**ADDENDUM NO. 4****BID NO. 24-03**

**BEARDS HILL ROAD & ROBERTS WAY AREA  
 WATERLINE IMPROVEMENTS**

**BID # 24-03 CAPITAL PROJECT # UTL-21-23**

**EXHIBIT 001**

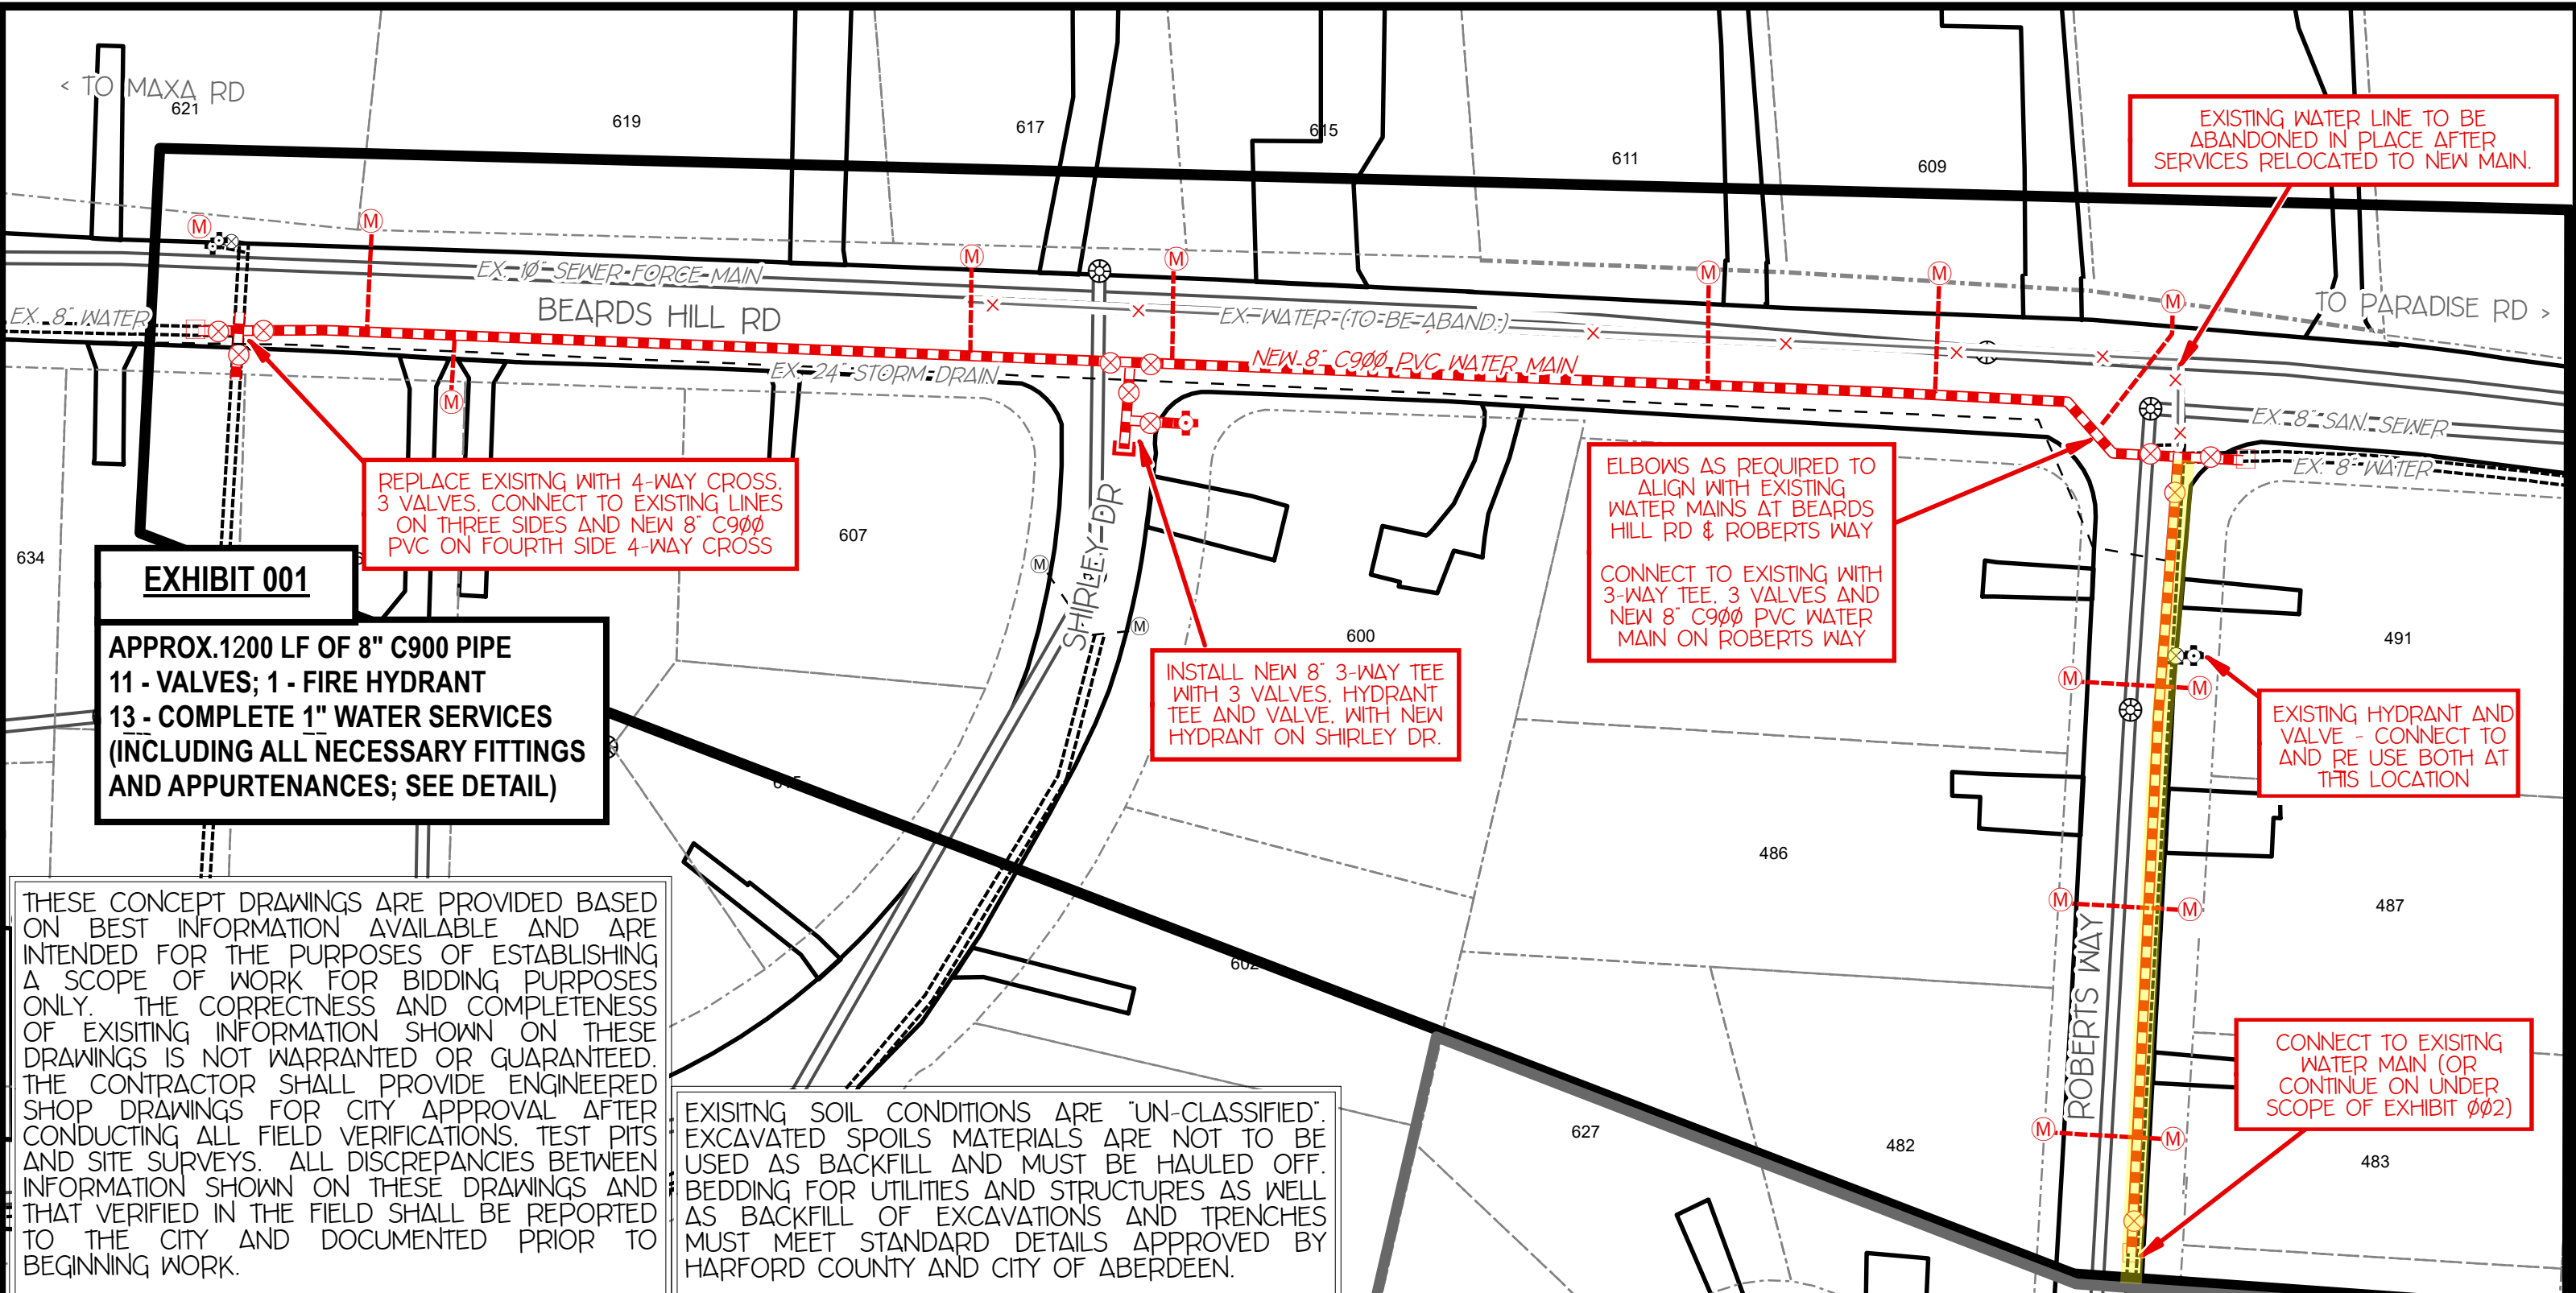
Q12) It can be obvious to include Curb Replacement at those locations where a WHC or Hydrant Lead will cross, however it is not obvious if curb replacement can be avoided where the new mains are to be installed along and adjacent to the face of existing curbs. (ex-Exhibit 001 Roberts Way). Should bidders assume curb replacement in these locations or will the City pay for curb replacement here? Perhaps the City will consider adding contingent items for curb and sidewalk replacement to the bid form?

Q13) It is not clear on any of the Exhibit drawings where the new main is intended to replace an existing main in-kind. (ex-Exhibit 001 Roberts Way). Will the City please offer better information with regard to the existing Water main replacements and abandonments?

**A12) Curb and sidewalk shall only be replaced where it has been removed as a necessary part of the project scope. (lateral crossings, service lines, etc.) The intent is to install the new main between the one main and the curb without disturbing the existing curb. At the time of Submittals, after the project is awarded, a schedule of values for change orders will be established in the event that additional curb work is required due to unforeseen circumstances.**

**A13) The attached drawings are highlighted where the new main is to replace an existing main that is to be abandoned. Please also see example configuration drawings on page 50 of the bid package for a better idea of the utility layout.**
